APPENDIX A

**COMMENT LETTERS ON DRAFT EIS
WITH SUBSTANTIVE COMMENTS**

Subject: Draft Environmental Impact Statement for the Hycroft Mine Expansion Project, Humboldt and Pershing Counties, Nevada [CEQ# 20120016]

Figure 3.17.1

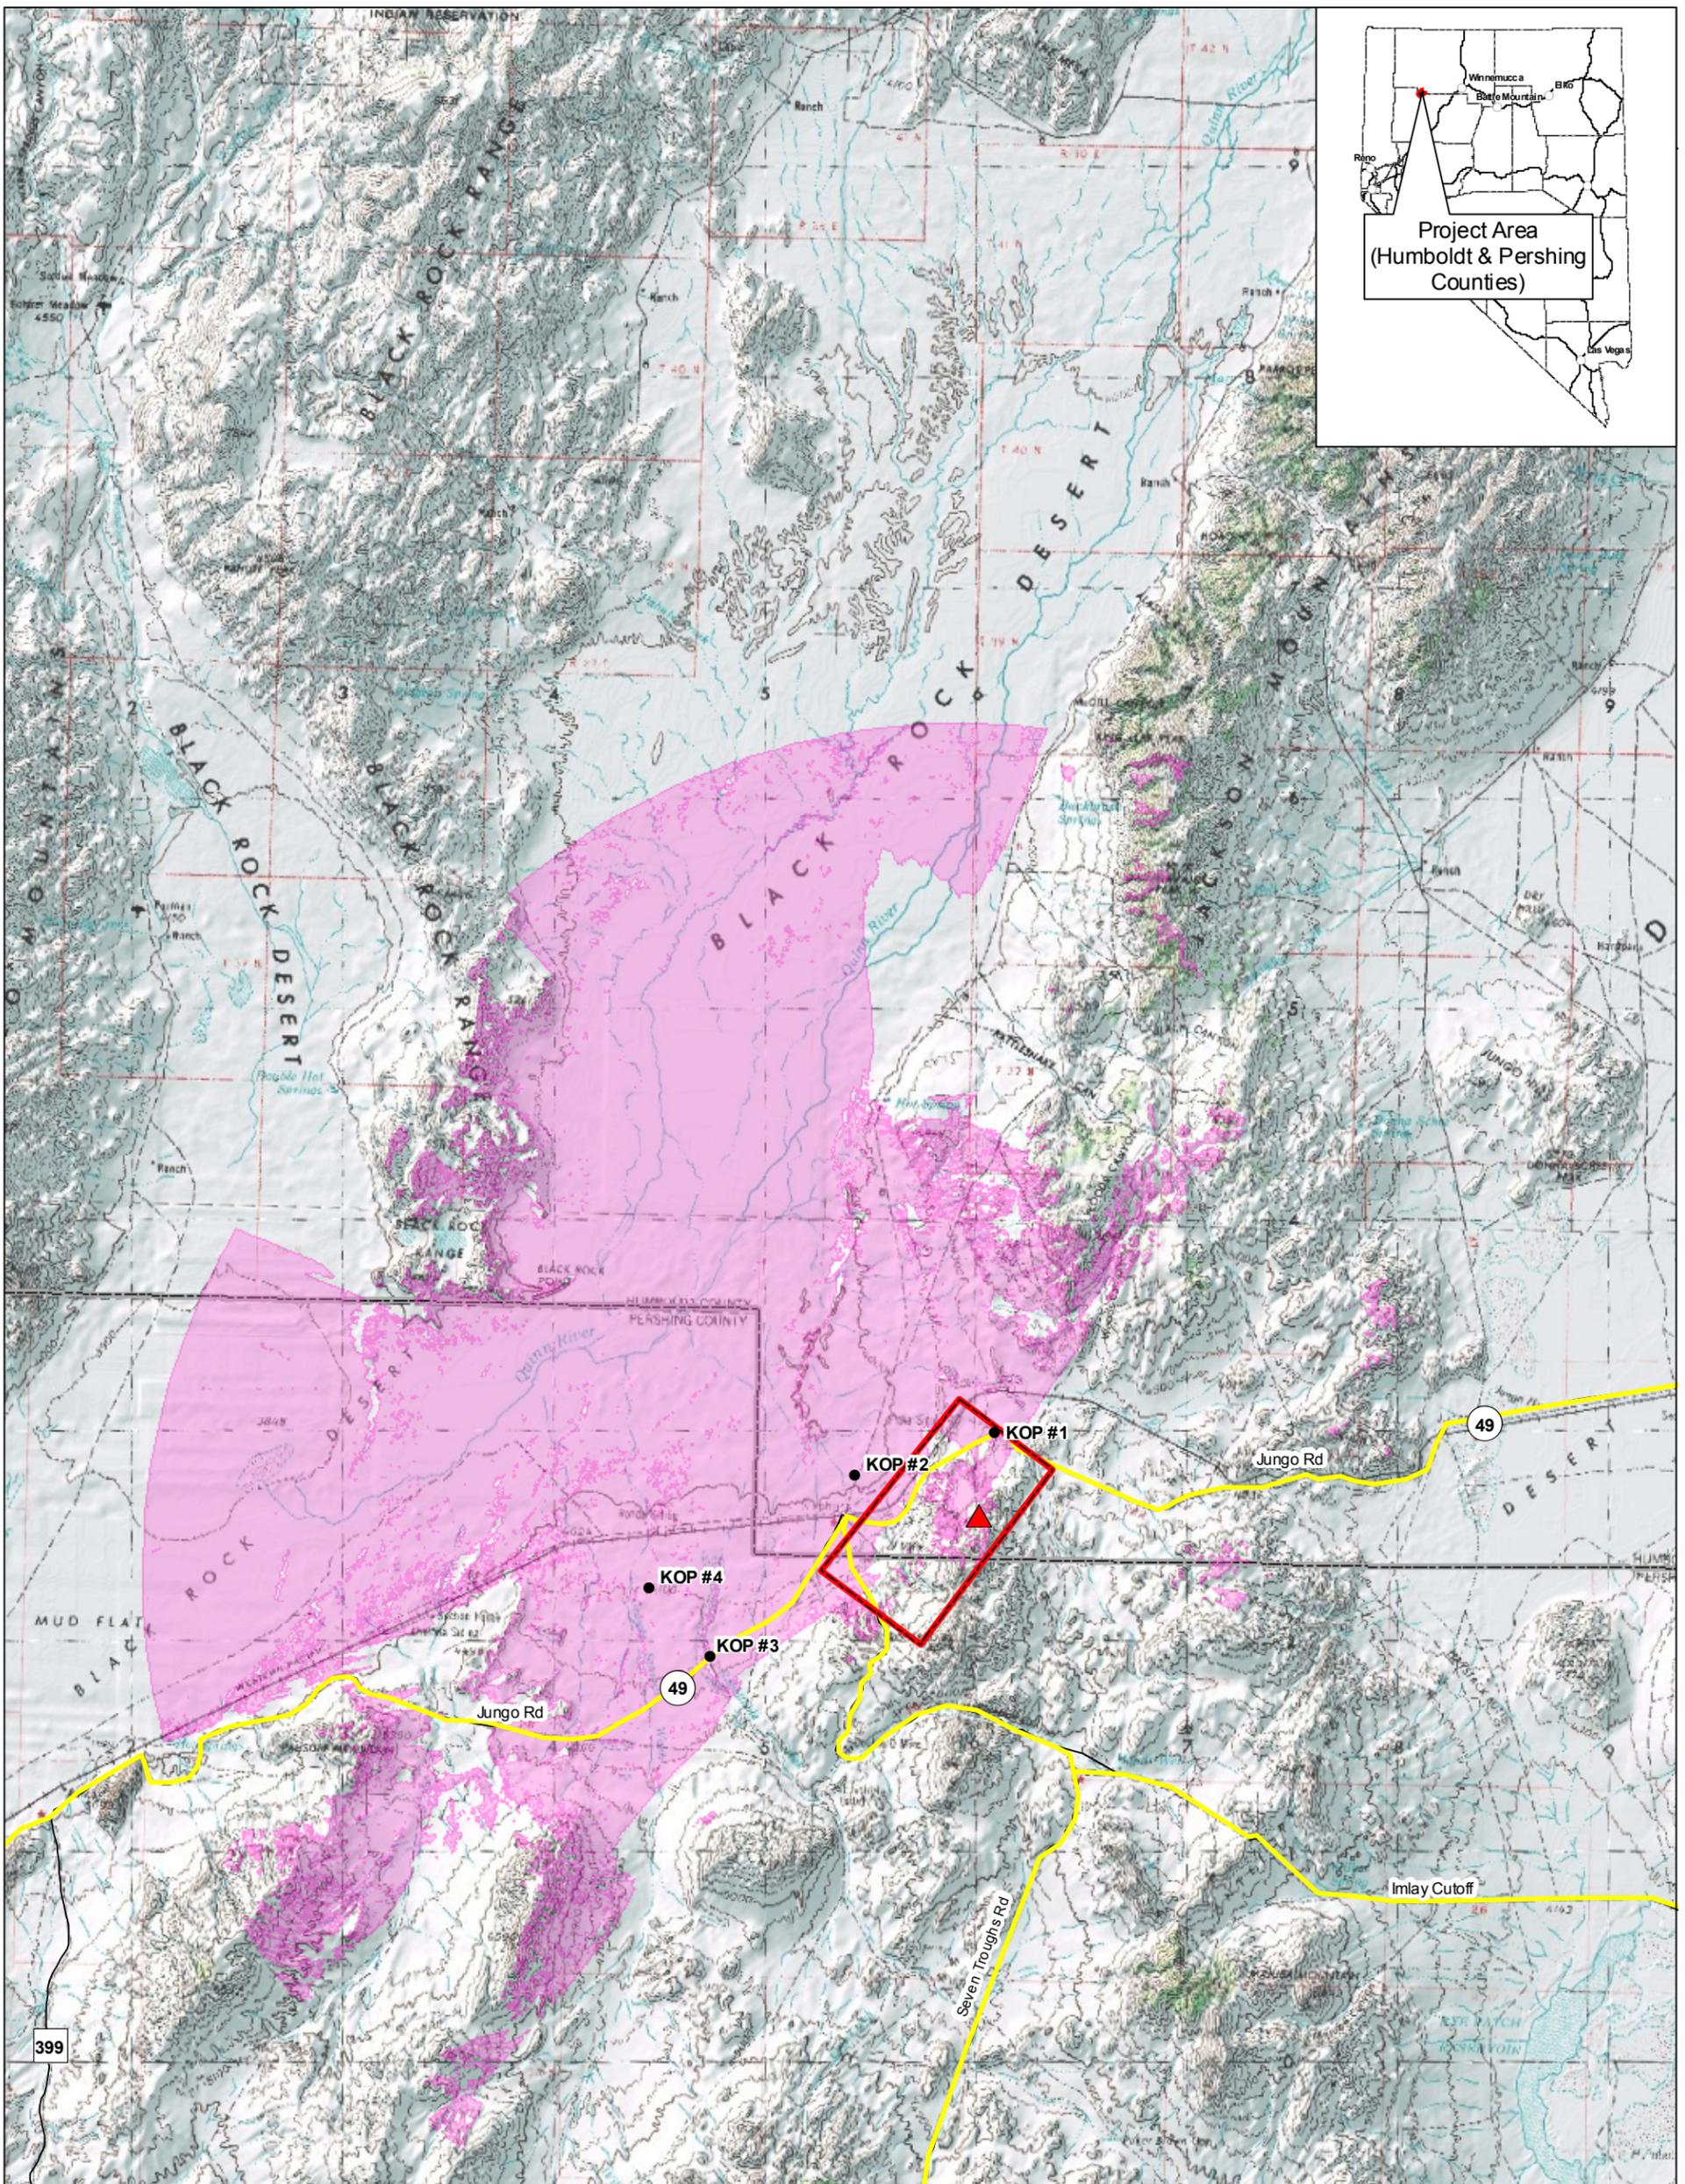
[There should have been at least 2 more observation points (KOP) that better represents the vantage points of recreational users in the Black Rock NCA, Wilderness areas and especially along the Emigrant trail from which to analyze the visual impacts. One KOP located along the emigrant trail between Black Rock Point and the rail road and another in the Black Rock Playa west of Black Rock Point. These are areas frequented by visitors to the Black Rock. Touring along the historic trail is a popular activity that takes place throughout the summer and fall. The mine is in full view along the trail route south of Black Rock Point to a point south of the railroad as well as over to Sulphur where the ingress egress route to the trail is located. Camping, land sailing, rocket launches, astronomy and other activities occur on the deep Black Rock Playa.] 1
